DAVE BAXTER
Vice President
Oconee Nuclear Station

June 26, 2008

Subject: Duke Energy Carolinas, LLC
Oconee Nuclear Station, Units 1, 2, and 3
Renewed Facility Operating Licenses Numbers DPR-38, DPR-47, and DPR-55;
Docket Numbers 50-269, 50-270, and 50-287
License Amendment Request to Revise Portions of the Updated Final Safety
Analysis Report Related to the Tornado Licensing Basis;
License Amendment Request No. 2006-009

Figure 1
Major SSF & PSW Electrical Power Upgrades

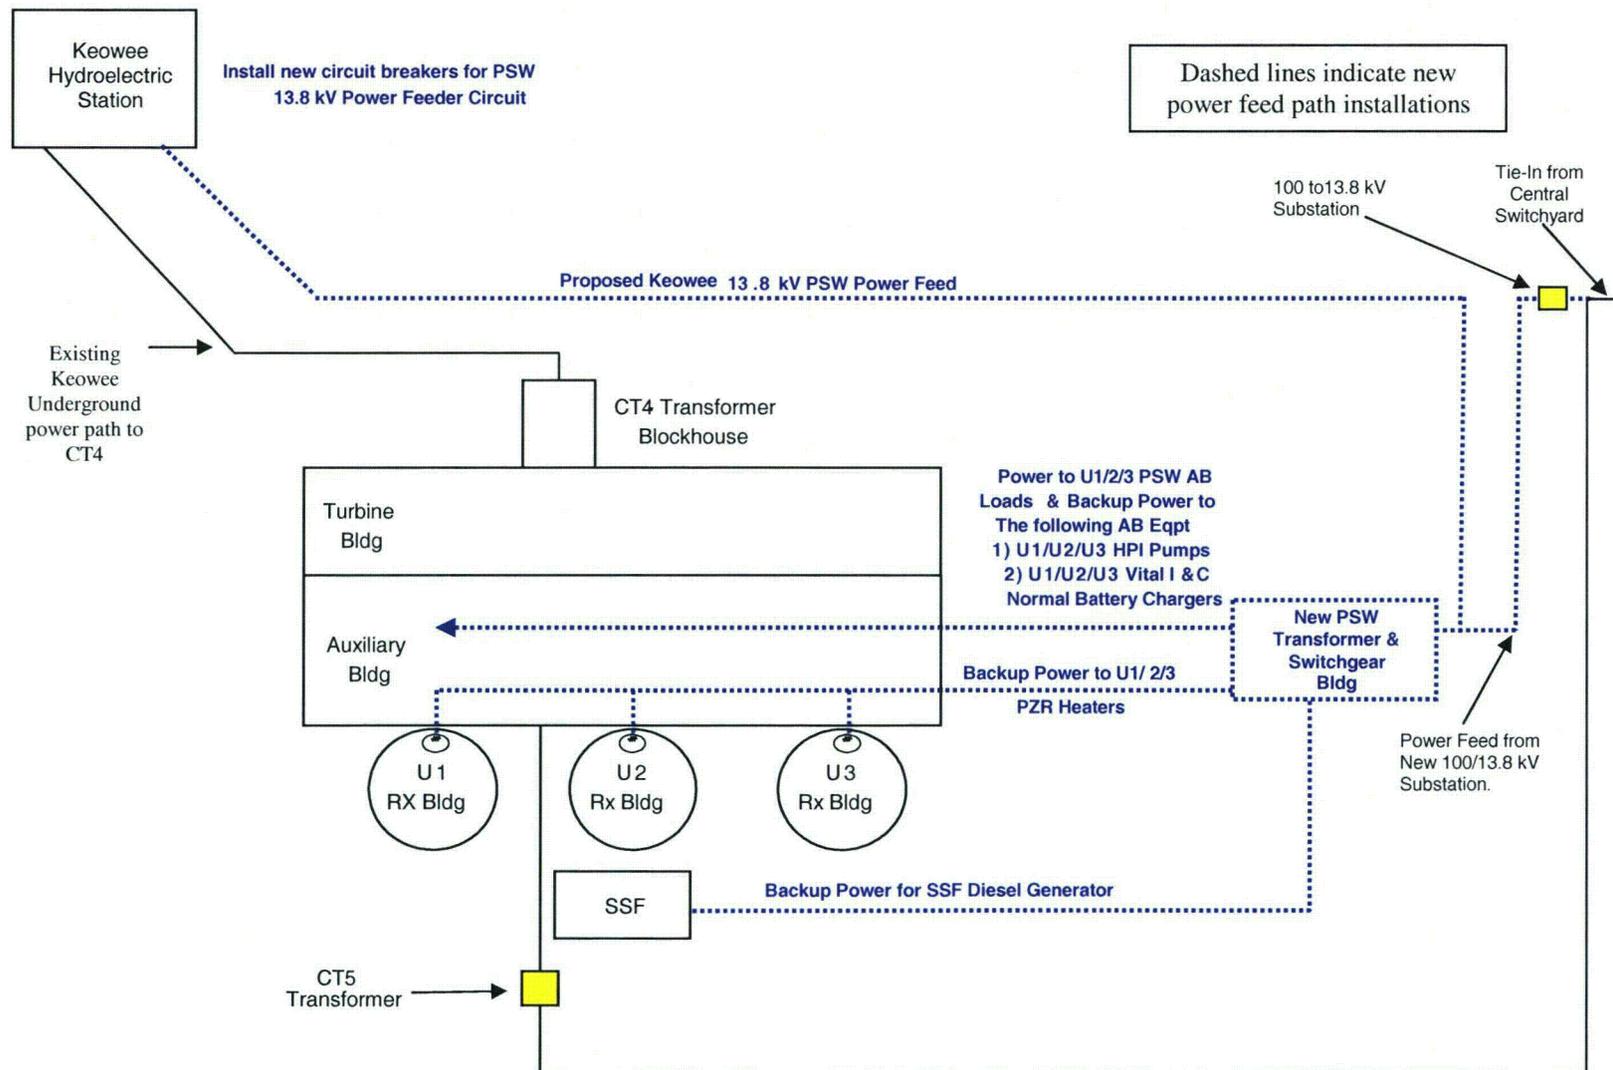
The Station ASW switchgear will be replaced with the PSW System switchgear located in a new tornado-protected PSW building. New power cables will be routed from the KHUs to the PSW building through an underground path. Alternate power to the PSW System switchgear will be provided by a new transformer connected to the existing 100 kV transmission line that receives power from the Central Tie Switchyard located approximately 8 miles from the plant. This new power path is strategically located on the opposite side of the station from the KHUs which reduces the chance of concurrent tornado damage to both power sources.

The new tap-off portion from the 100 kV line will not adversely affect the operation of the station's CT5 emergency transformer. Any fault that occurs on this new portion of line will be isolated from the 100 kV line with either the high side circuit switcher or the low side breaker installed at the PSW substation. The PSW switchgear will also provide a backup power supply to the SSF via an underground path as additional defense-in-depth. An electrical diagram displaying the revised power arrangement for the SSF and PSW Systems and the location of the CT5 transformer is shown on Figure 1.
